**TO:** Development Review Board  
**FROM:** Scott Gustin  
**DATE:** May 6, 2014  
**RE:** 14-0831CA/CU; 69 Scarff Avenue

**Request:** Construct new single family home on existing vacant lot.

SHEET  
**A1.1**

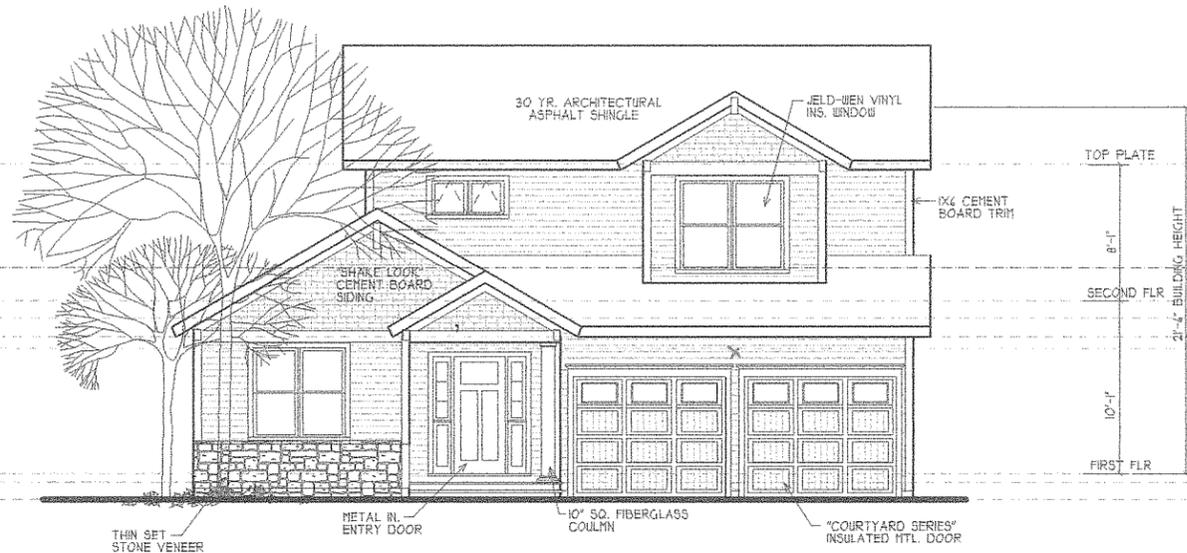
The proposed home will have a gable roof with eave ends facing the street. This orientation reflects the dominant pattern along this section of Scarff Avenue. A single front dormer is also proposed. **(Affirmative finding)**

*(e) Quality of materials*  
The proposed home will be clad in fiber cement clapboards and trim. Asphalt shingles will be installed. Fiberglass columns will frame the front entryway and rear porch, and windows will be vinyl. These materials are of reasonable quality and acceptable for this new home. **(Affirmative finding)**

<b>S1</b>	SHEET	DATE	SCALE	NO.
MD	DRAWN BY	3/19/14	1:30	1
M. Dufresne	CHECKED BY	PERMIT	BUILD ON YOUR OWN LOT	REVISION
 4076 Shelburne Road, Suite 6 Shelburne, Vermont 05482 p 802.985.5722 - f 802.497.0701 www.SnyderHomesVT.com

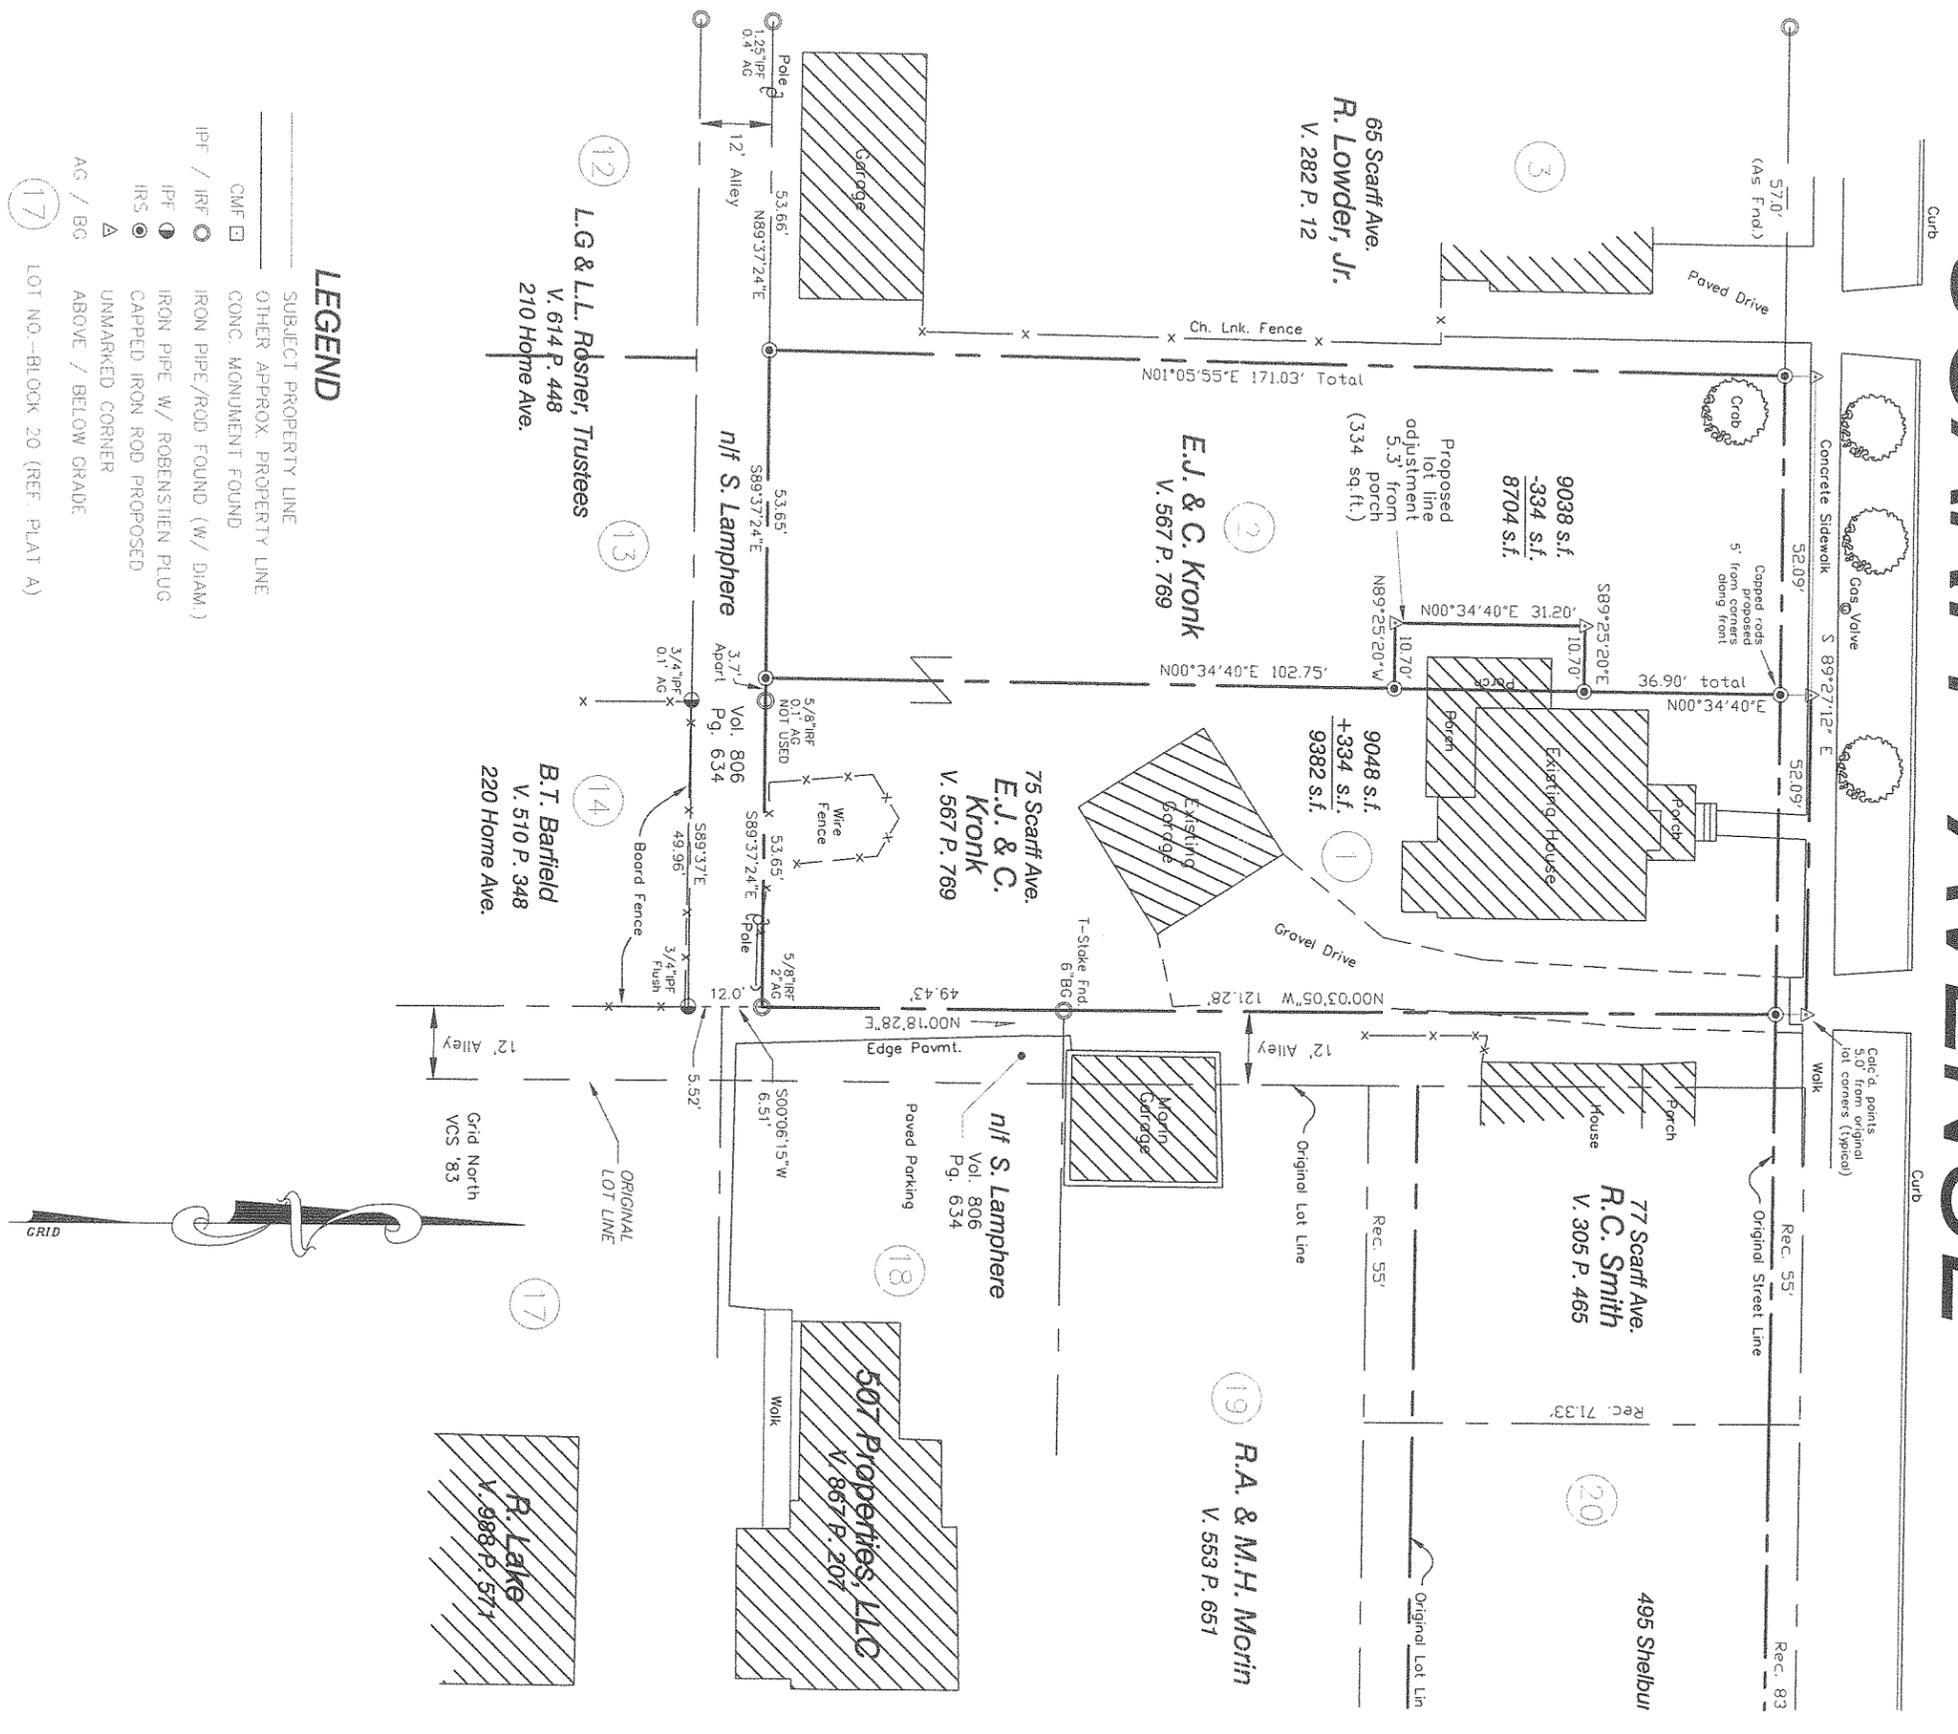
A front walkway is proposed; however, it will curve and connect to the driveway. The walkway must connect to the public sidewalk. It may parallel the driveway or otherwise. **(Affirmative finding as conditioned)**

No landscaping details have been provided. Extensive detail is not needed for a proposal such as this; however, at least a basic garden and landscaping plan is needed. No new fencing is proposed. **(Affirmative finding as conditioned)**

New utility lines must be buried. Utility meters are located on the sides of the new home. They are not screened and must be, either with an enclosure or with landscaping. **(Affirmative finding as conditioned)**

1. **Prior to release of the zoning permit**, revised plans shall be submitted subject to staff review and approval. Revised plans shall depict:
  - a. A front walkway that connects the front door to the public sidewalk (and updated lot coverage information);
  - b. Basic landscaping plan; and,
  - c. Utility meter screening.
